**ZONING CHANGE REVIEW SHEET****CASE:** C814-2017-0001 – 425 W. Riverside PUD**Planning Commission Date:** February 13, 2018**ADDRESS:** 425 W. Riverside Drive**OWNER/APPLICANT:** Ronald A. Nelson and Molly Belle Properties (Ronald Nelson, Trustee)**AGENT:** Armbrust & Brown (Richard Suttle)/Stream Realty (David Blackbird)**ZONING FROM:** CS-1-V-NP      **TO:** PUD-NP**AREA:** 1.45 acres (63,162 sq. ft.)**SUMMARY STAFF RECOMMENDATION:**

Planning and Zoning staff recommends PUD zoning with conditions as referenced in the Land Use Plan.

EXAMPLE TREEWELL  
SECTION VIEW SCALE: 1/2"=1'-0" 02

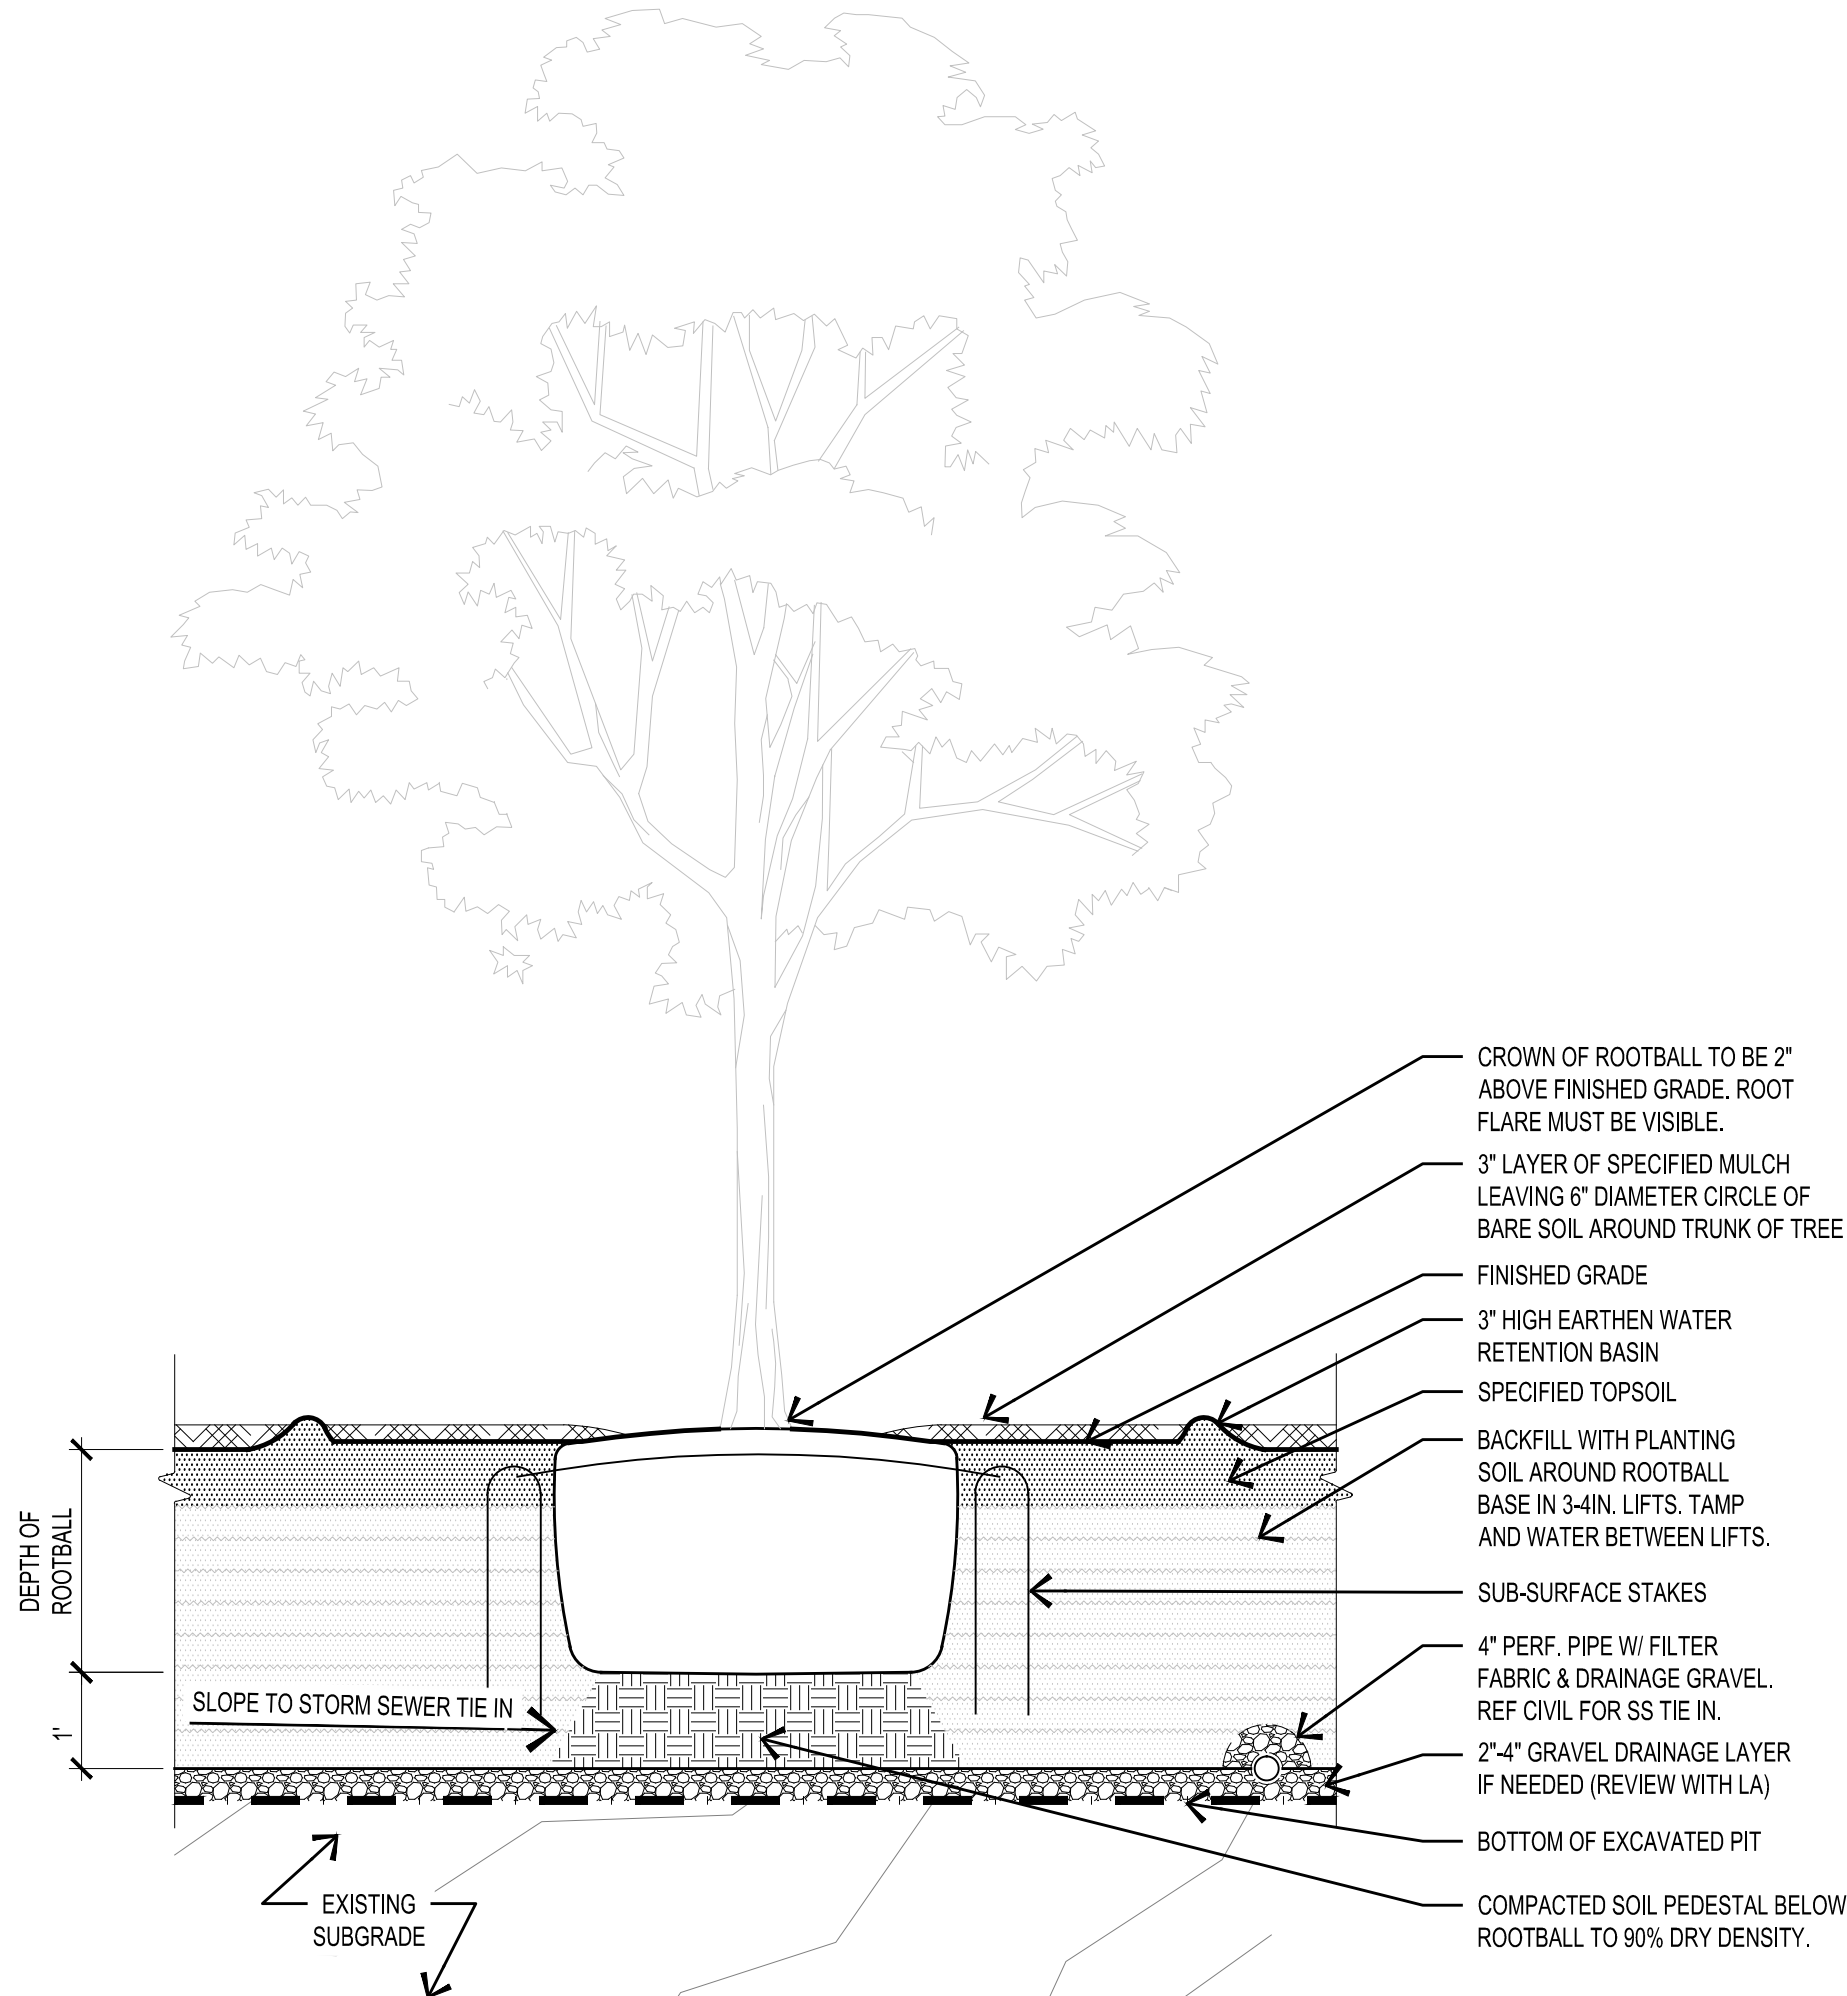
**UPDATE 3: Thank you for the additional information and calculations. While the PUD proposed planting of a larger diameter street tree could be considered for some environmental superiority, it would normally be a proposal to plant more trees than what would be required that would carry more weight. The PUD proposes a starting overall total frontage a bit less than the current code scenario. It also proposes an additional loss of frontage to accommodate greater options for alternative transportation with two new bus stops. These additional losses in total only allow the PUD scenario to plant one additional tree than the current code option. In this case, it will be the guarantee to plant a shade tree of higher quality that will carry some environmental superiority. To this point, because a multiplier has been used in both calculations to estimate loss due to utility conflicts and not on the ground verification staff is still not able to support the overall tree planting estimates.**

**Please also revise your soil commitments and notes to be consistent with the last update. These should include the larger 1540 CY soil volume required in locations other than ones with utility conflicts. In those cases where it is proven utility conflict then 1000 CY minimum is accepted with the use of soil cells. Comment pending.**

**UPDATE 3: Using the ANSI planting standards is acceptable but not superior, as these would be done anyway. Please explore additional standards for tree quality, to assure the best possible tree stock is available for the PUD. These could include presence of visible root flare a time of planting and no girdling roots. Comment pending.**
